IN-D-290GAID

IN-D-290GAIS

F031105

F031106

## 0521123: SEALS FOR DOORS FOAMED AS ONE PIECE

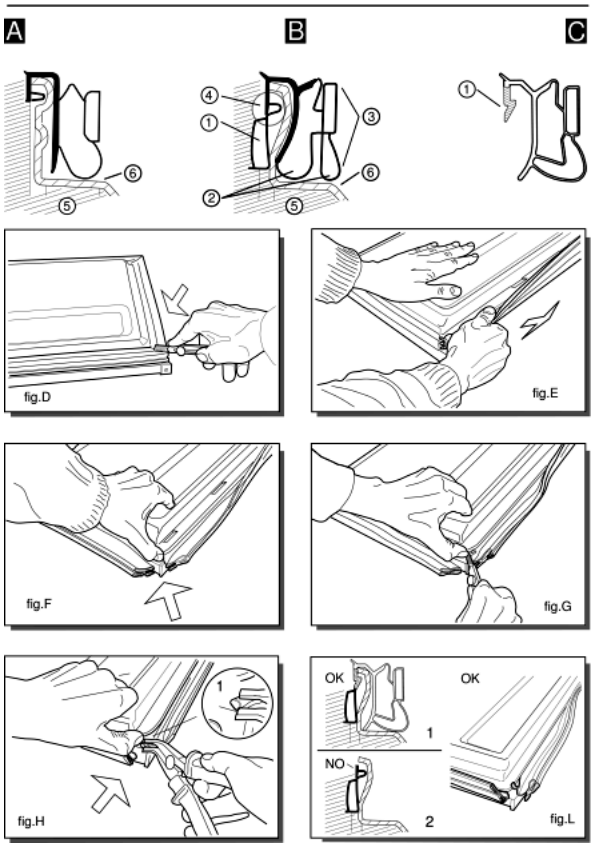
Various types of gaskets with different profile, as shown in figures (A) and (B), are used to fix the door (fig. A-5; B-5) and the inner door (fig. A-6; B-6) on the block foamed doors of combined freezers and refrigerators.
---Ilpea profile 245; 179; 412 (fig.A)
---Ilpea profile 287 (fig.B)
When replacing gaskets with profiles 245; 179; 412 these are fixed with screws (2 per corner) to the door.
Gaskets with profile 287 can not be used as spare parts but are designed to house the Ilpea type 900 gaskets (see figure C).
When replacing the gasket (287), once it is removed you will find a pocket (fig. B-1) between the door and inner door.
The rigid tooth (fig.C-1) of the gasket (900) is inserted inside between the pocket and the inner door, doing away with the need for screws.
Gasket with profile 287 is easy to identify since it has an exterior double edge (fig.B-2) which acts as a cushion when the door is closed.

To replace this gasket, follow these steps:
---Dismount the door and cut the four corners of the gasket along the joint (fig.D);
---lift the gasket and pull it carefully along its full length without tearing it (fig.E).
The purpose here is to detach the inner door slightly from the foam along the exterior edge for a depth equal to that of the gasket (fig.B-3);
---lift the corner of the inner door slightly, prising it up with your thumb (fig.F). Do not use a tool which might break the inner door;
---continue cutting the gasket inside the inner door for about 6 mm (fig.G);
---push in the tip of the pliers (type USAG N131) and pull outwards until you see the top edge of the pocket (fig. B-4) which is empty (fig.H-1);
---if you carry out this operation correctly (fig.L) you will be able to pull off the top edge of the pocket for the full length of the door.
If the gasket tears before the top edge (fig. L-2) you should repeat this operation from the other corner of the door.

---once the gasket (287), has been removed the space above the pocket (fig. L-1) can house the rigid tooth (fig. C-1) of the gasket 900.
When you fit this gasket ensure that it lies flush against the edge for the full length of the door.
If the rigid tooth is difficult to fit, eliminate any residues of foam between the door and the inner door in the gasket area.
fig.5131549A

N130084FIG1

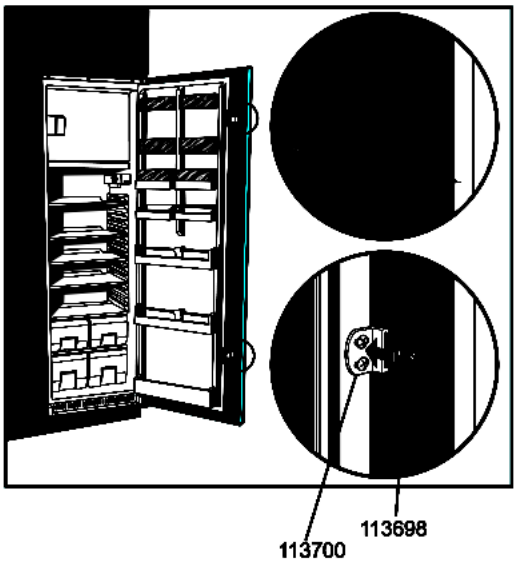
Since October 2004, the Carinaro factory has been using new sliding blocks for fixing the furniture door to the refrigerator door.
The new items are fixed to the side of the refrigerator door, whereas the previous ones were fixed to the front.
The doors are no longer provided with sixteen 2.6 mm holes on the front for fixing the old slides.
The new sliding blocks can also be fitted on premodification models. Proceed as shown in the attached figure (N1030084fig.1).
When replacing the sliding blocks on premodification models it will necessary to replace both guides.
This modification has involved changing the installation KITS

NB - Door spare part codes have not been changed.

113698 - LARGE NYLON HOLDER SLIDE
113700 - NYLON HOLDER SLIDING GUIDE

021258 - SMALL WHITE SLIDE + COVER
021259 - WHITE SLIDE
